Product Change Notice

(PCN Tracking Number: EE-QR-200701-01)

Customer:	ALL Customers
Renesas Product Type:	Synergy and RA HWQFN package products. The list of all affected products along with the new part numbers on page 9.
Description of Change:	New assembly and test factories. Further details stated on page 2
Reason for Change:	Renesas continuously changes manufacturing factories and assembly materials for stable supply.
Identification:	From the packing label or trace code, the production history data can be inquired.
Schedules:	Sample shipment & QT data: from b/o Nov. 2020 sequentially (p.9) Requested approval: Nov. 2020 or 3 months after sample delivery Change Implementation: from Jan. 2021 onwards sequentially
Anticipated Impact:	Fit, Form & Function: None Quality & Reliability: None QC Flow: None
Doc. No.:	EEQC-PCN-CR-20-0053
Internal Reference:	IMO-AZ-20-003-1

Düsseldorf, 15.07.2020

Package Structure:

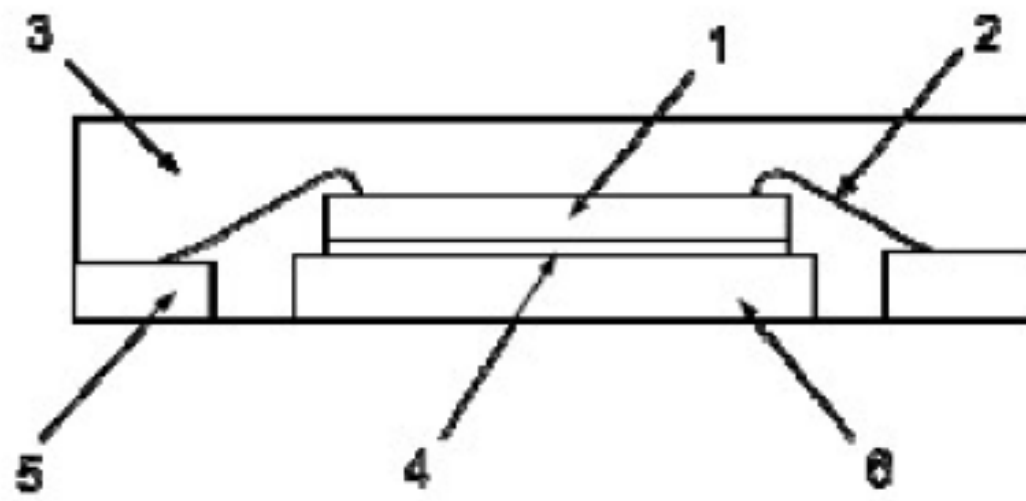
* Package Section and die pad shape is a reference example.

*The materials are different because they use materials certified at the site, but the structure is equivalent.

Package Outline_8mm×8mm 64pin HWQFN

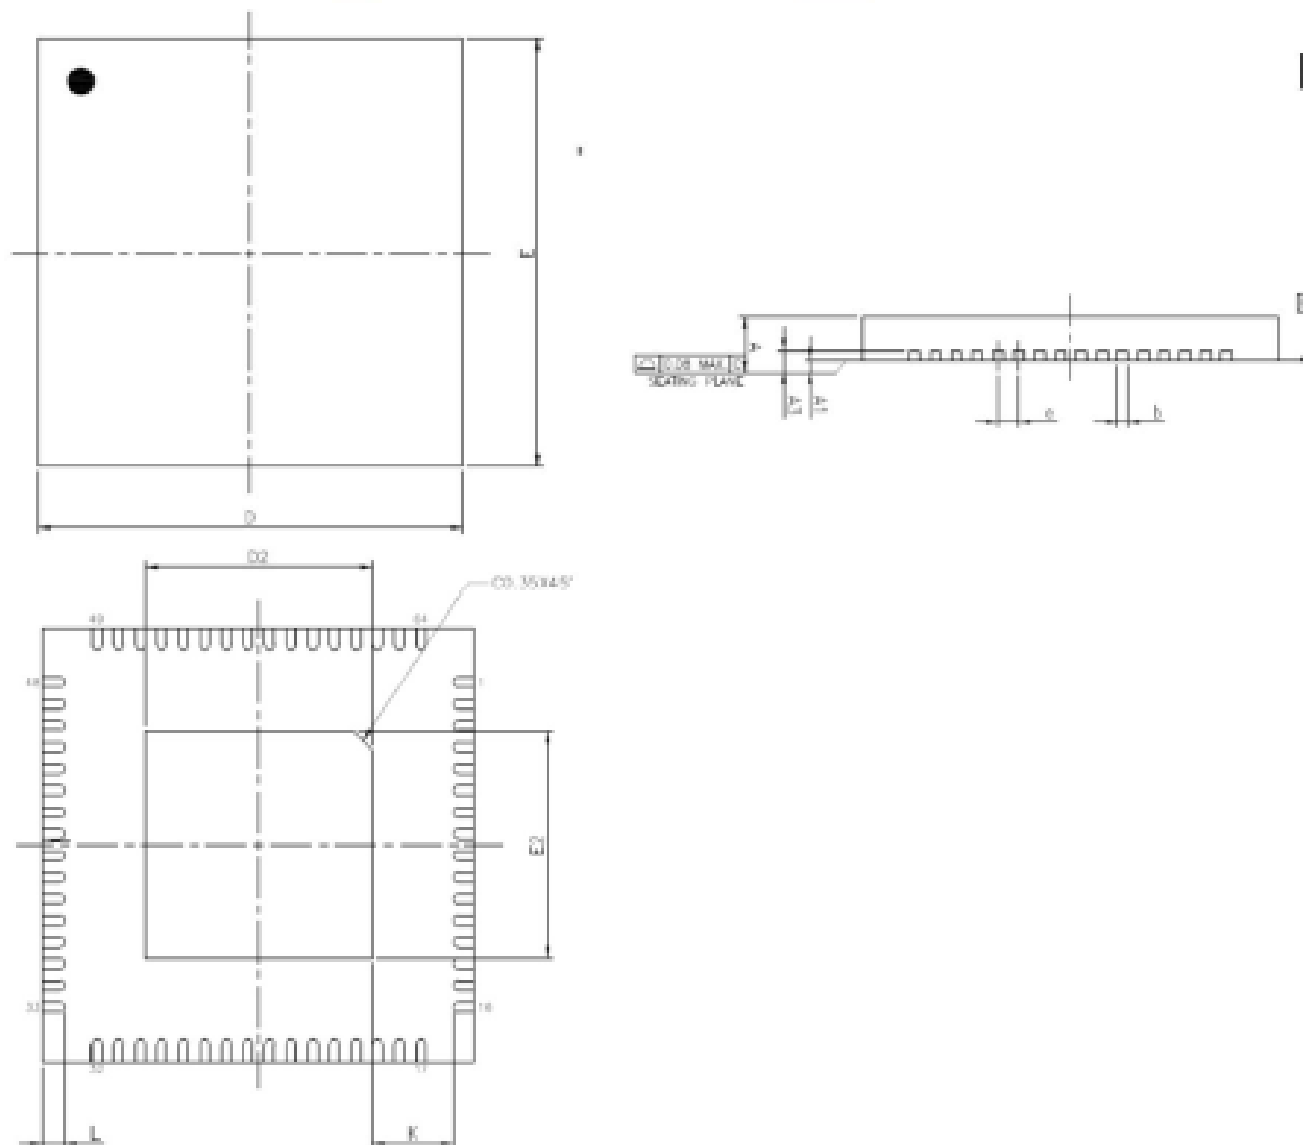
* The indication format/standard has been changed to JEDEC compliant.

Item	Symbol	New			Current		
		Min.	Nom.	Max.	Min.	Nom.	Max.
Package length	D	8.00 BSC			7.95	8.00	8.05
Package width	E	8.00 BSC			7.95	8.00	8.05
Seated height	A	-	-	0.80	-	-	0.80
1st standoff height	A1	0.00	-	-	0.00	-	-
Terminal width	b	0.15	0.20	0.25	0.17	0.2	0.23
Terminal pitch	e	0.40 BSC			-	0.40	-
Terminal length	L	0.35	0.40	0.45	0.30	0.40	0.50
Coplanarity	-	-	-	0.08	-	-	0.05
Terminal to die pad length	K	0.20	-	-	-	-	-
Terminal thickness	A3	0.203 REF			0.15	0.20	0.25
Die pad length	D2	-	4.20	-	-	6.50	-
Die pad width (S5D3, S124, RA6M1)	E2	-	4.20	-	-	6.50	-
Die pad width (Other group)	E2	-	6.50	-	-	6.50	-

As Amkor Technology Japan Kumamoto (Current factory) is JEITA standard, items and symbols are different.

Outline_7mm×7mm 48pin HWQFN

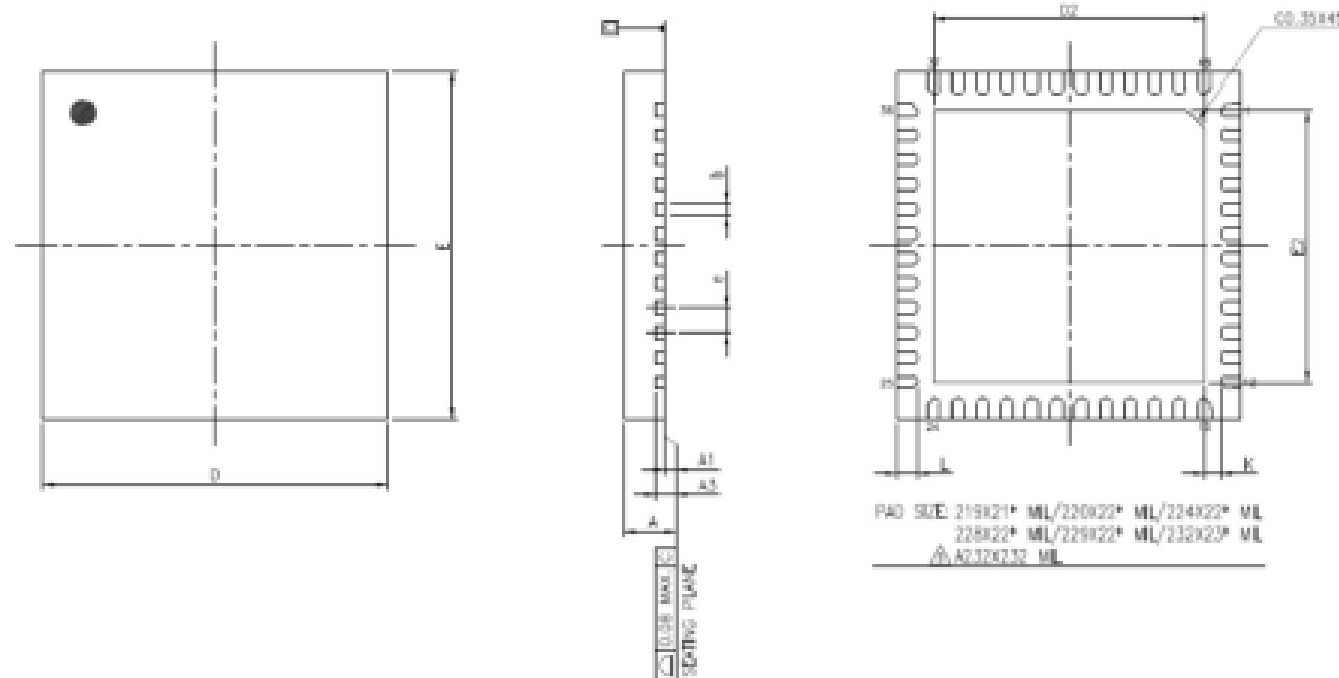
* The indication format/standard has been changed to JEDEC compliant.

Item	Symbol	New			Current		
		Min.	Nom.	Max.	Min.	Nom.	Max.
Package length	D		7.00 BSC		6.95	7.00	7.05
Package width	E		7.00 BSC		6.95	7.00	7.05
Seated height	A	-	-	0.80	-	-	0.80
1st standoff height	A1	0.00	-	-	0.00	-	-
Terminal width	b	0.15	-	0.30	0.18	0.25	0.30
Terminal pitch	e		0.50 BSC		-	0.50	-
Terminal length	L	0.30	0.40	0.50	0.30	0.40	0.50
Coplanarity	-	-	-	0.08	-	-	0.05
Terminal to die pad length	K	0.20	-	-	-	-	-
Terminal thickness	A3		0.203 REF		0.15	0.20	0.25
Die pad length	D2	-	5.30	-	-	5.50	-
Die pad width	E2	-	5.30	-	-	5.50	-

As Amkor Technology Japan Kumamoto (Current factory) is JEITA standard, items and symbols are different.

Outline_6mm×6mm 40pin HWQFN

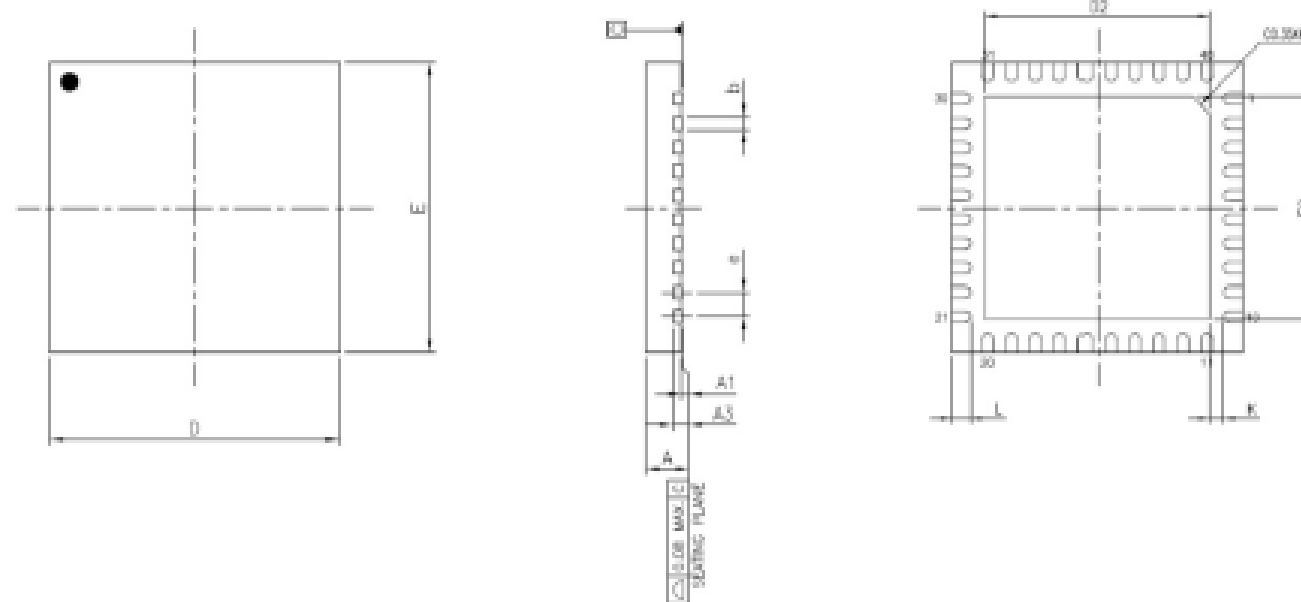
* The indication format/standard has been changed to JEDEC compliant.

Item	Symbol	New			Current		
		Min.	Nom.	Max.	Min.	Nom.	Max.
Package length	D		6.00 BSC		5.95	6.00	6.05
Package width	E		6.00 BSC		5.95	6.00	6.05
Seated height	A	-	-	0.80	-	-	0.80
1st standoff height	A1	0.00	-	-	0.00	-	-
Terminal width	b	0.15	-	0.30	0.18	0.25	0.30
Terminal pitch	e		0.50 BSC		-	0.50	-
Terminal length	L	0.30	0.40	0.50	0.30	0.40	0.50
Coplanarity	-	-	-	0.08	-	-	0.05
Terminal to die pad length	K	0.20	-	-	-	-	-
Terminal thickness	A3		0.203 REF		0.15	0.20	0.25
Die pad length	D2	-	4.50	-	-	4.50	-
Die pad width	E2	-	4.50	-	-	4.50	-

As Amkor Technology Japan Kumamoto (Current factory) is JEITA standard, items and symbols are different.

Package Outline_5mm×5mm 32pin HWQFN

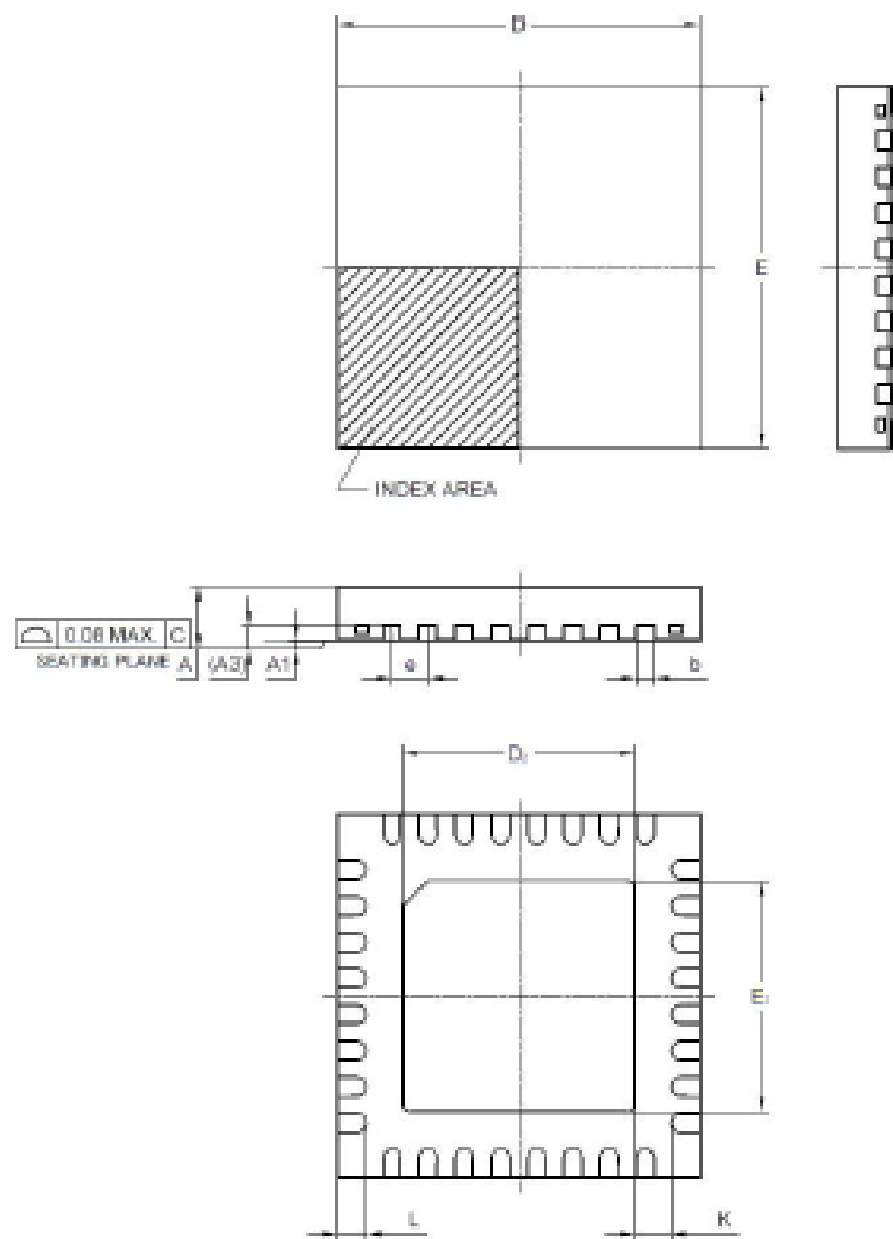
* The indication format/standard has been changed to JEDEC compliant.

Item	Symbol	New			Current		
		Min.	Nom.	Max.	Min.	Nom.	Max.
Package length	D	5.00 BSC			4.95	5.00	5.05
Package width	E	5.00 BSC			4.95	5.00	5.05
Seated height	A	-	-	0.80	-	-	0.80
1st standoff height	A1	0.00	-	-	0.00	-	-
Terminal width	b	0.18	0.25	0.30	0.18	0.25	0.30
Terminal pitch	e	0.50 BSC			-	0.50	-
Terminal length	L	0.35	0.40	0.45	0.30	0.40	0.50
Coplanarity	-	-	-	0.08	-	-	0.05
Terminal to die pad length	K	0.20	-	-	-	-	-
Terminal thickness	A3	0.203 REF			0.15	0.20	0.25
Die pad length	D2	-	3.50	-	-	3.50	-
Die pad width	E2	-	3.50	-	-	3.50	-

As Amkor Technology Japan Kumamoto (Current factory) is JEITA standard, items and symbols are different.

Outline_5mm×5mm 32pin HWQFN

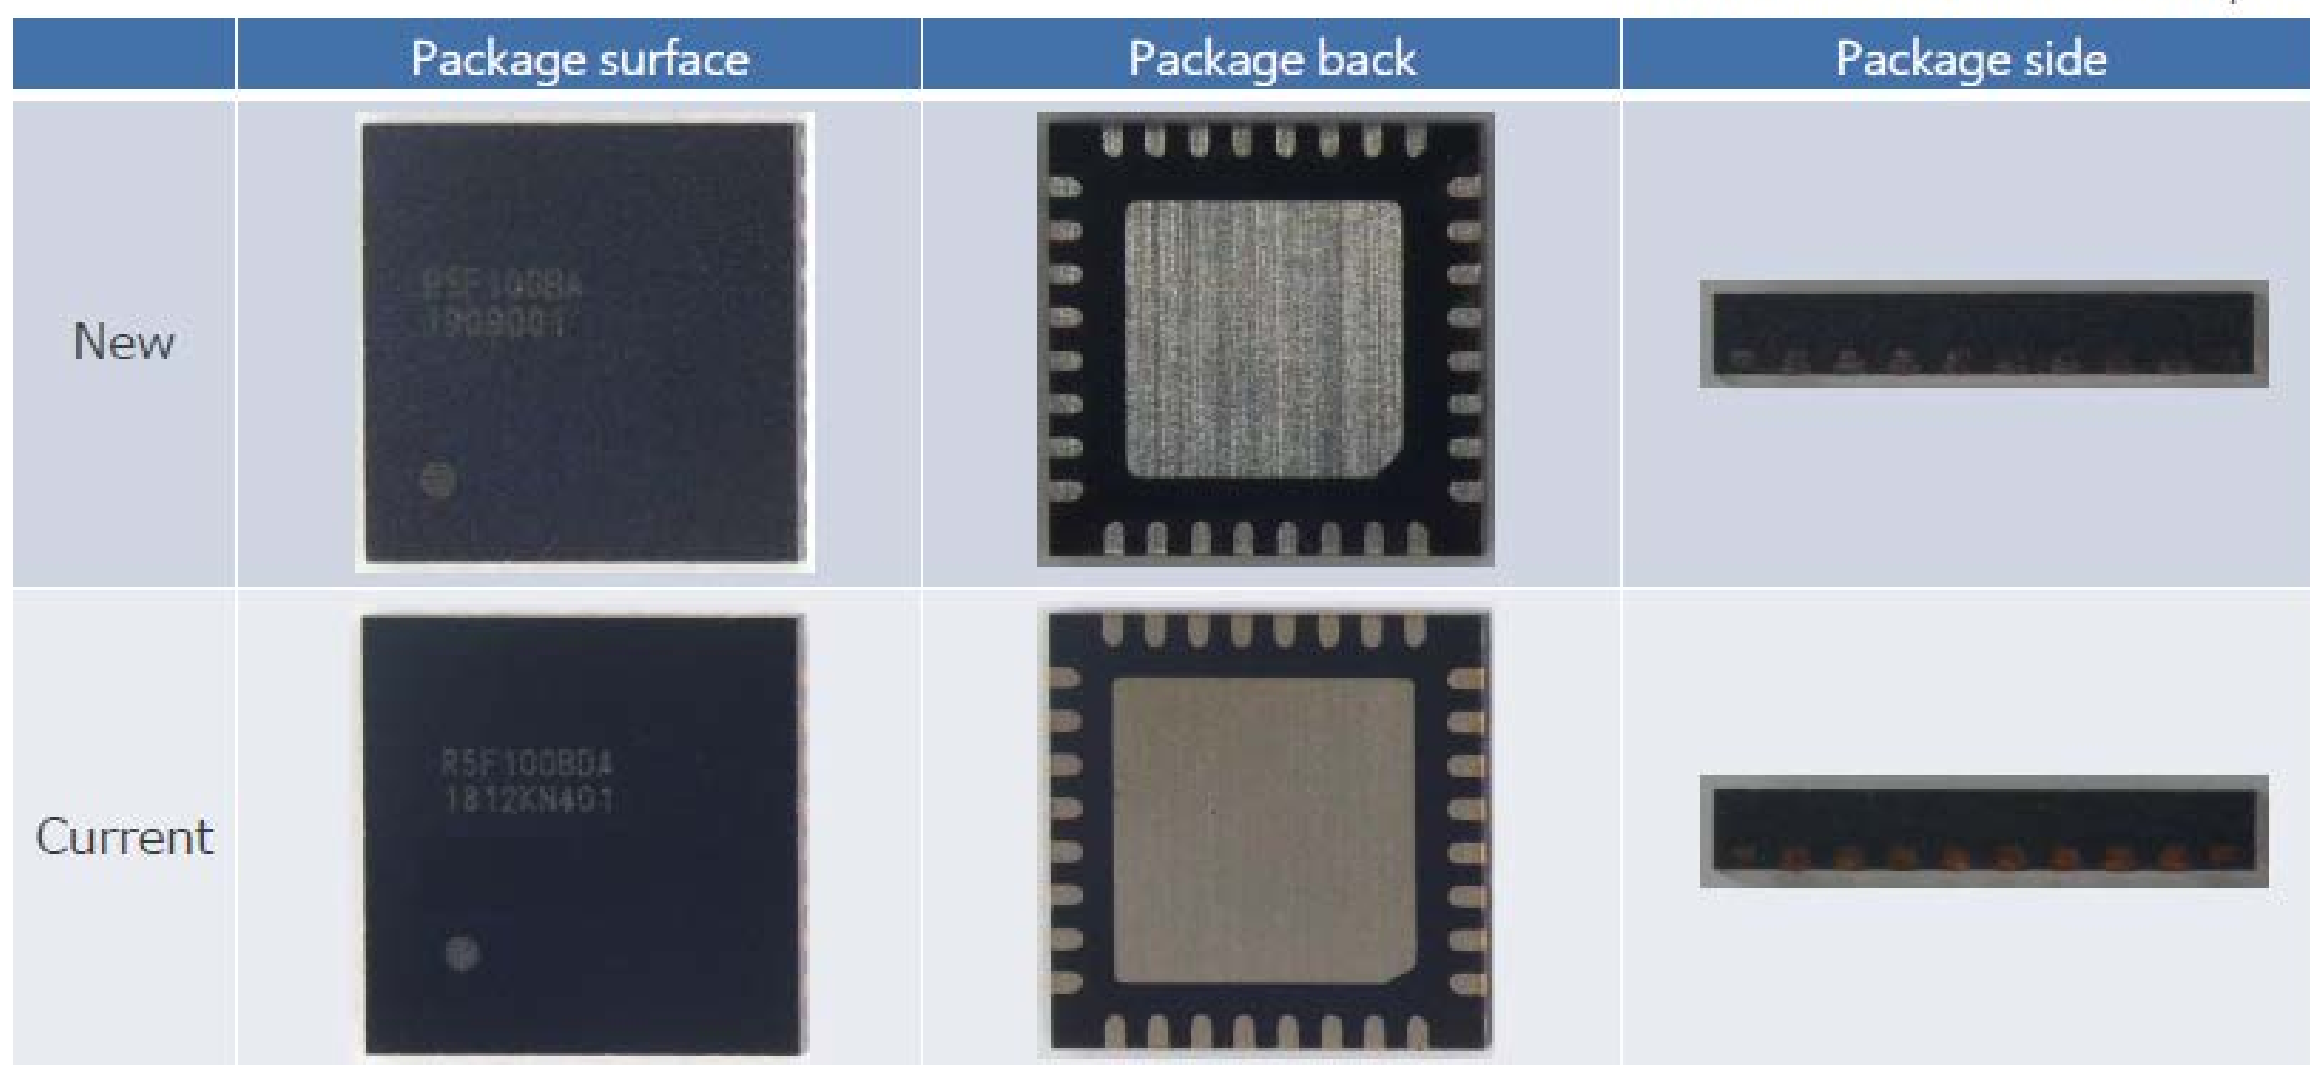
4-1) Font change
   4-2) Manufacturing lot number change (from 9 digit to 7 digit)
   4-3) Delete country of origin indication

Package surface	Package back	Package side
New	R7FS5D37A3 A01CNB 024A904		
Current	R7FS5D37A3 A01CNB 1823KNR00

PACKING SPECIFICATION (TRAY)

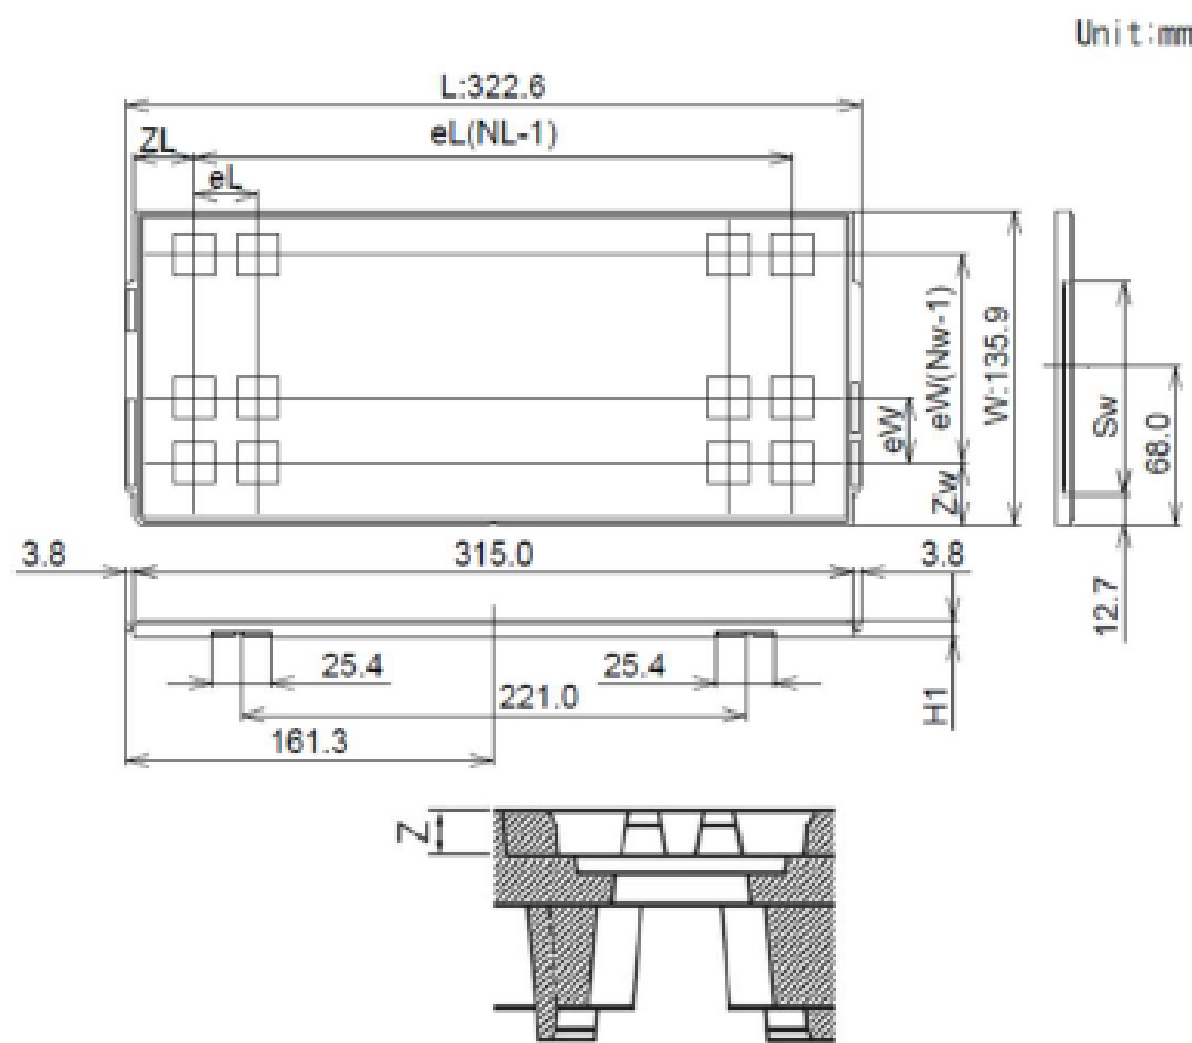
Tray Code		New	Current
		EA708080-10	EAM0808-10 REV.A
Position dimension of cells	Z	1.50	1.45
	Zw	10.75	10.35
	ZL	11.90	10.00
	eW	10.4	12.8
	eL	10.4	11.8
	Sw	92.1	92.1
Thickness (mm)	H1	7.62	7.62
Number of cells	Nw	12	10
	NL	29	26
Maximum storage pcs IC/Tray		348	260
Maximum storage pcs IC/Inner box		2784	2080
Material		Carbon PPE	Carbon PPE
Heat resistant temperature		135ºC MAX	150ºC MAX
JEDECorCustom		JEDEC	JEDEC
Surface resistance		Less than 1x10[11]Ω/☐	---

PACKING SPECIFICATIONS (EMBOSS TAPING)

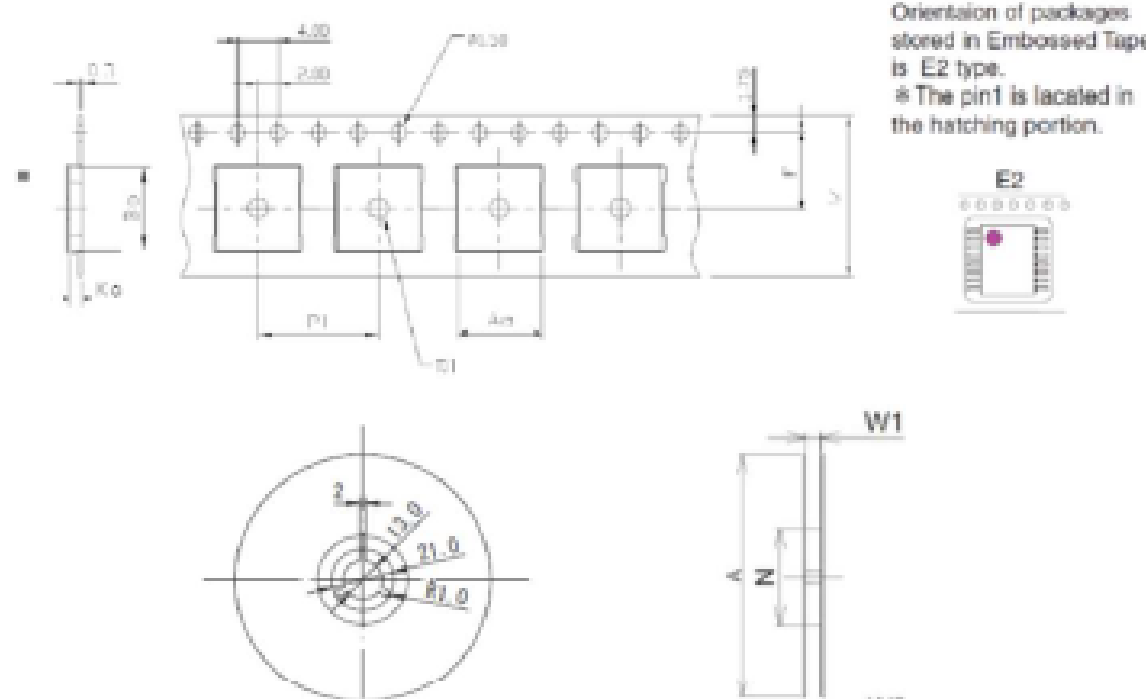
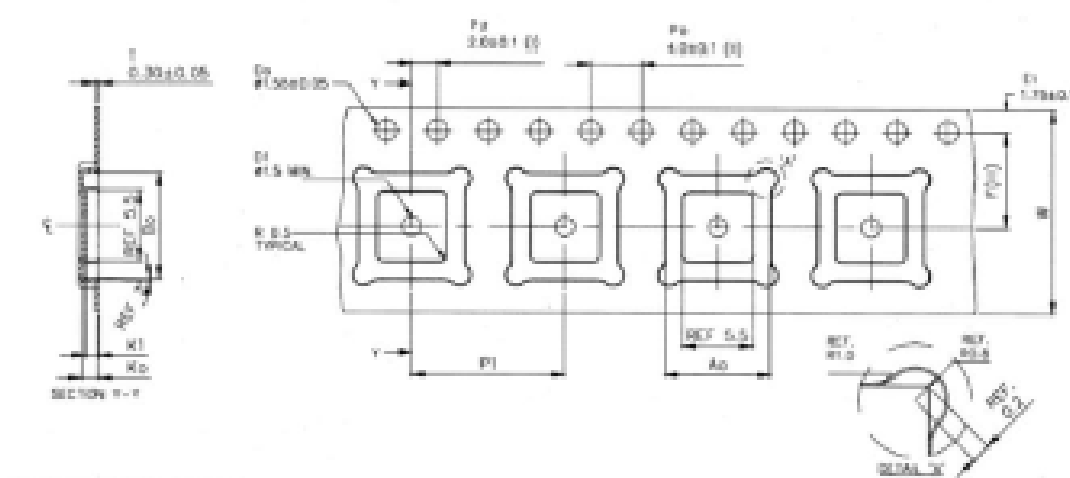
Tape Code		New	Current
		EC7080801-112	E16*12-☐☐-C0CA
Tape Dimensions (mm)	W	16.0	16.0
	P1	12.0	12.0
	A0	8.3	8.3
	B0	8.3	8.3
	K0	1.2	1.0
	F	7.5	7.5
	D1	2.0	1.5
Reel Dimensions (mm)	A	330	330
	W1	16.8	17.5
	W2	22.2	21.5
Maximum storage Pcs. IC/ Reel		2500	2500
Material		Carbon PS	Carbon PS
Surface resistance		Less than 1x10[11]Ω/☐	Less than 1x10[11]Ω/☐
